Section 75W to Concept Plan (MP10_0003)

Discovery Point, Wolli Creek

Submitted to Department of Planning and Infrastructure
On Behalf of Discovery Point Pty Ltd and Discovery Point Devt Pty Ltd

Figure 2 - Comparison of existing and proposed basement extent

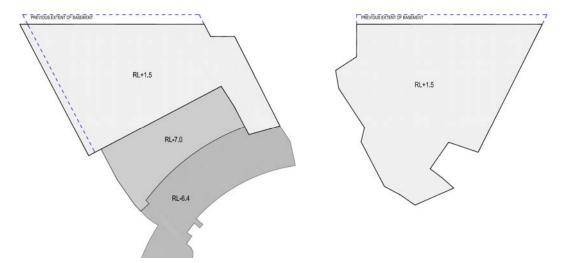
It is noted that amendments to the proposed basement extent diagram (DA3-B01) are sought as part of this modification application. Overall however, the 'extent' of the basement area will be reduced from what was originally approved (refer to **Figure 2**).

The approved basement extent diagram (DA3-B01) included basement parking in close proximity to the Illawarra and South Cost Rail Line. Detailed design development of individual stages has however resulted in a review of the relationship of the basement extent to this adjoining rail corridor. Accordingly, it has been determined that a more appropriate outcome from both a buildability perspective (in terms of enabling simpler construction of basement structures) and interface perspective (in terms of minimising/avoiding potential impacts on the rail corridor) would be achieved through pulling the basement away from the rail corridor. This proposed change would be expected to be welcomed by RailCorp.

Correspondingly, it is proposed for the basement extent to be pushed south towards Magdalene Terrace within the boundary of land still owned by Discovery Point Pty Ltd. This ensures the area of basement parking that was planned to occur in close proximity to the Rail Line is reapportioned (partially) to a more appropriate location.
